Contract #: 04-0120F4Cty: SF/ALA Rte: 80 PM: 13.2/13.9File #: 69.25B**QUALITY ASSURANCE -- NON-CONFORMANCE REPORT****Location:** Changxing Island, Shanghai, P.R. China**Report No:** NCR-000560**Prime Contractor:** American Bridge/Fluor Enterprises, a JV**Date:** 23-Dec-2009**Submitting Contractor:** Zhenhua Port Machinery Company, Ltd (ZPMC), Changxing Island**NCR #:** ZPMC-0533**Type of problem:**

**Reference Description:** Skin flatness allowable tolerance not met at Side Panels on Lift 5W**Description of Non-Conformance:**

**Job Name:** SAS Superstructure

**Subject:** NCR No. ZPMC-0533

5CW SP (SP472A) to SP (SP418A) - CB Side

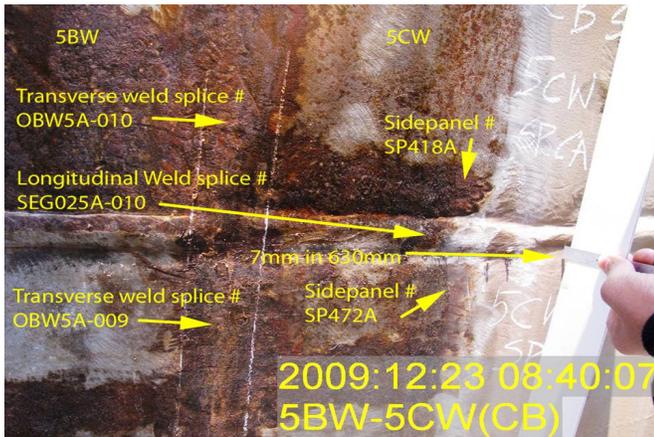
Surface flatness surveys were taken on the exterior Side Panel (SP) surface of longitudinal weld joint identified as SEG025A-010, cross beam side of 5CW between PP34 to PP35. The measurements were taken transverse to the direction of the side panel longitudinal weld joint. This area exceeded the maximum 5mm deviation from flat specified in State letter 05.03.01.004667.

-Deviation from flat is 7mm in 630mm

-The longitudinal weld splice is identified as: SEG025A-010.

-The SP plate numbers are: SP472A to SP418A

-The location is on the cross beam side of segment 5CW between PP34 to PP35.

5CW SP (SP472A) to SP (SP418A) - CB Side

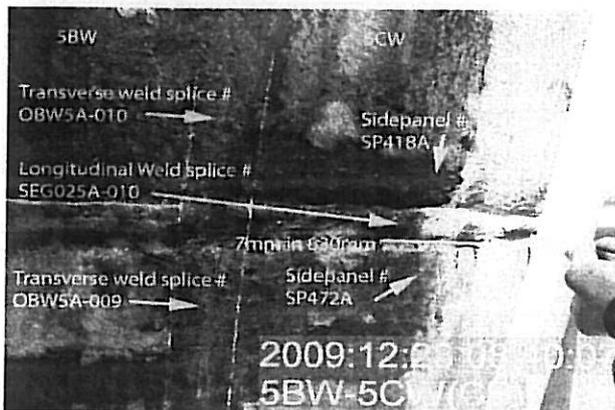
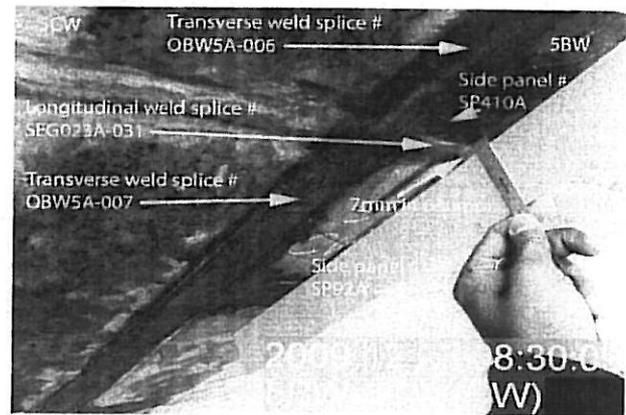
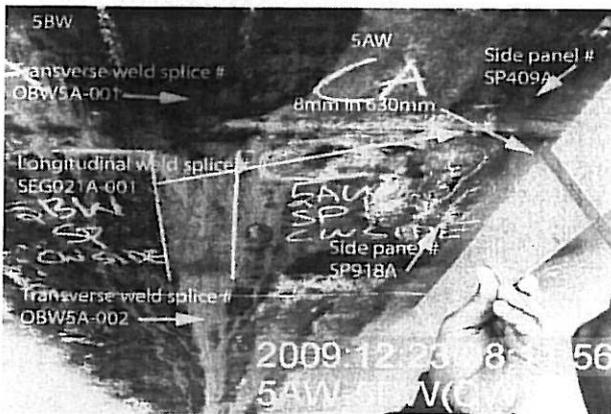
Surface flatness surveys were taken on the exterior Side Panel (SP) surface of longitudinal weld joint identified as SEG025A-010, cross beam side of 5CW between PP34 to PP35. The measurements were taken transverse to the direction of the side panel longitudinal weld joint. This area exceeded the maximum 5mm deviation from flat specified in State letter 05.03.01.004667.

-Deviation from flat is 7mm in 630mm

-The longitudinal weld splice is identified as: SEG025A-010.

-The SP plate numbers are: SP472A to SP418A

-The location is on the cross beam side of segment 5CW between PP34 to PP35.

WELD NUMBER: SEG021A-001

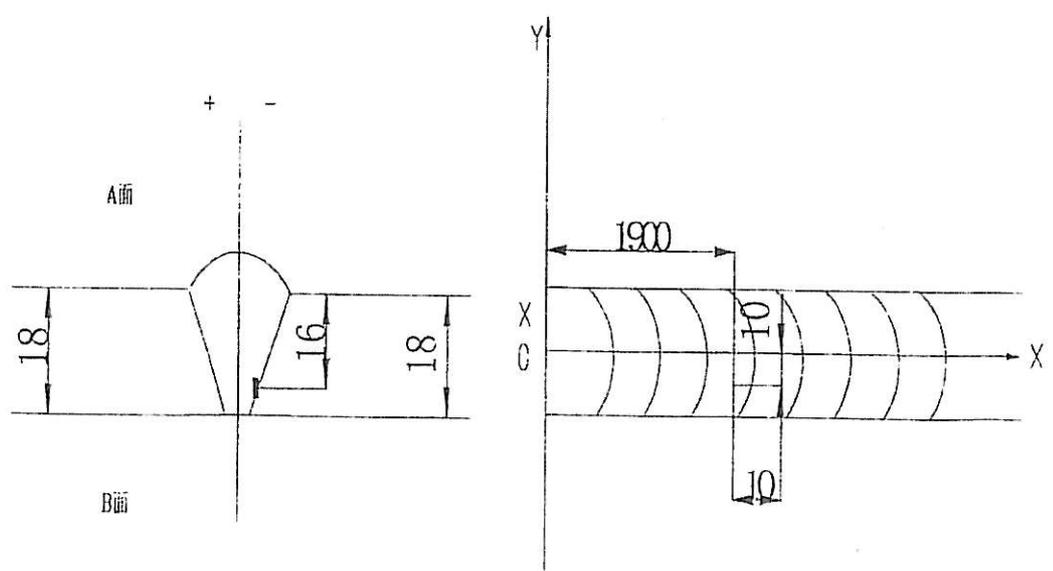
Rejected indication found by ultrasonic inspection is less than the maximum allowance aggregate length.

(UT探伤发现的缺陷总长度小于最大允许长度。) SEG021A-001

1. Did not clear the weld pass completely in time.

1. Gouge or grind from nearer side from metal edge ( $D \leq 0.65T$ , "D" is depth of defects, "T" is thickness of metal) to remove all defects;
2. Follow repair WPS for joint preparation, preheat, and weld deposit;
3. Verify with VT no defects remain in the weld joint prior to welding;
4. Grind the repaired area flush with base metal or the adjacent weld;
5. Check the welds according to the working drawings.

WELD NUMBER: SEG021A-031

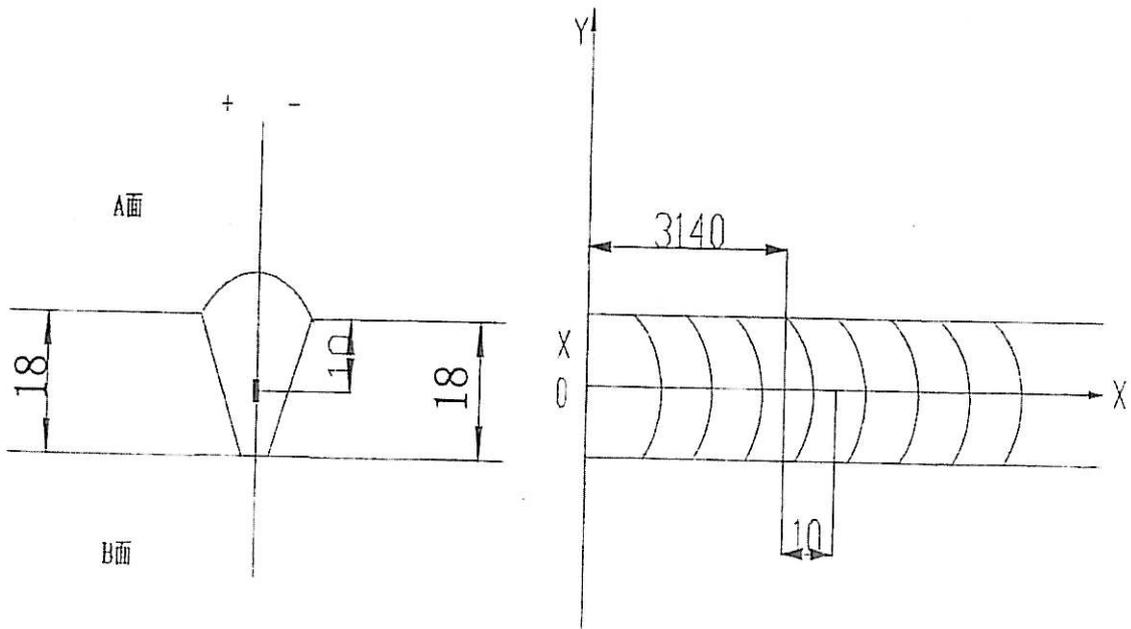
Rejected indication found by ultrasonic inspection is less than the maximum allowance aggregate length.

(UT探伤发现的缺陷总长度小于最大允许长度。) SEG023A-031

1. 焊道未及时处理干净。
1. Did not clear the weld pass completely in time.

1. 从缺陷距离端面较近一侧 ( $D \leq 0.65T$ , D为缺陷深度, T为板厚) 采用碳刨或打磨的方法去除焊缝缺陷;
  2. 参照返修焊接工艺规程 (WPS) 准备正确的接头型式, 预热和焊接;
  3. 焊前对修补区域进行VT检测保证缺陷完全被消除;
  4. 将修补区域打磨到与母材或邻近焊缝平齐;
  5. 根据批准的车间图纸检查焊缝.
- 
1. Gouge or grind from nearer side from metal edge ( $D \leq 0.65T$ , "D" is depth of defects, "T" is thickness of metal) to remove all defects;
  2. Follow repair WPS for joint preparation, preheat, and weld deposit;
  3. Verify with VT no defects remain in the weld joint prior to welding;
  4. Grind the repaired area flush with base metal or the adjacent weld;
  5. Check the welds according to the working drawings.

WELD NUMBER: SEG025A-010

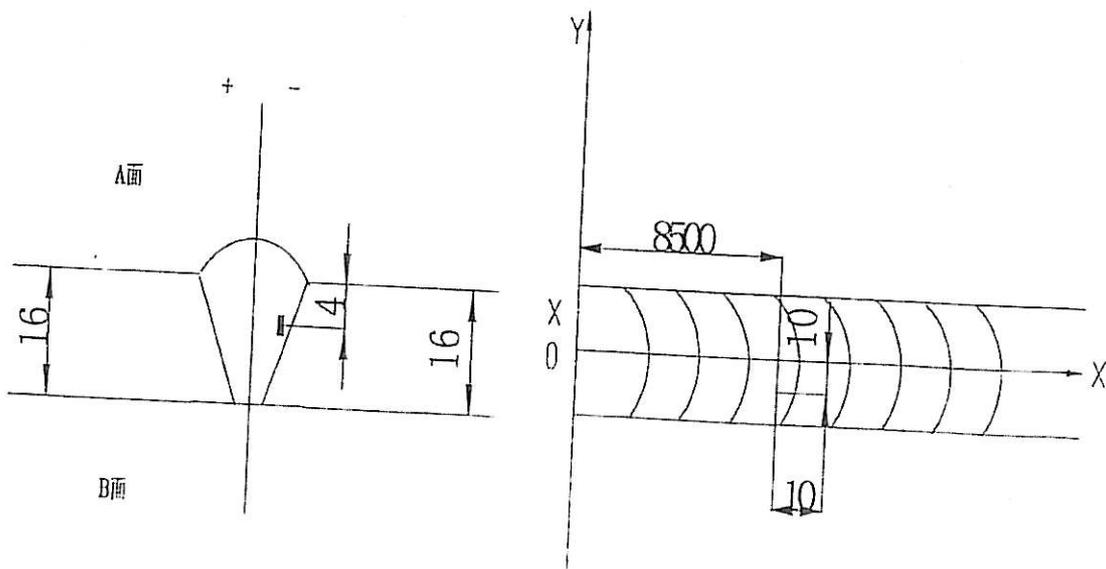
Rejected indication found by ultrasonic inspection is less than the maximum allowance aggregate length.

(UT探伤发现的缺陷总长度小于最大允许长度。) SEG025A-010

1. 焊道未及时处理干净。
1. Did not clear the weld pass completely in time.

1. 从缺陷距离端面较近一侧 ( $D \leq 0.65T$ , D为缺陷深度, T为板厚) 采用破刨或打磨的方法去除焊缝缺陷;
  2. 参照返修焊接工艺规程 (WPS) 准备正确的接头型式, 预热和焊接;
  3. 焊前对修补区域进行VT检测保证缺陷完全被消除;
  4. 将修补区域打磨到与母材或邻近焊缝平齐;
  5. 根据批准的车间图纸检查焊缝.
- 
1. Gouge or grind from nearer side from metal edge ( $D \leq 0.65T$ , "D" is depth of defects, "T" is thickness of metal) to remove all defects;
  2. Follow repair WPS for joint preparation, preheat, and weld deposit;
  3. Verify with VT no defects remain in the weld joint prior to welding;
  4. Grind the repaired area flush with base metal or the adjacent weld;
  5. Check the welds according to the working drawings.
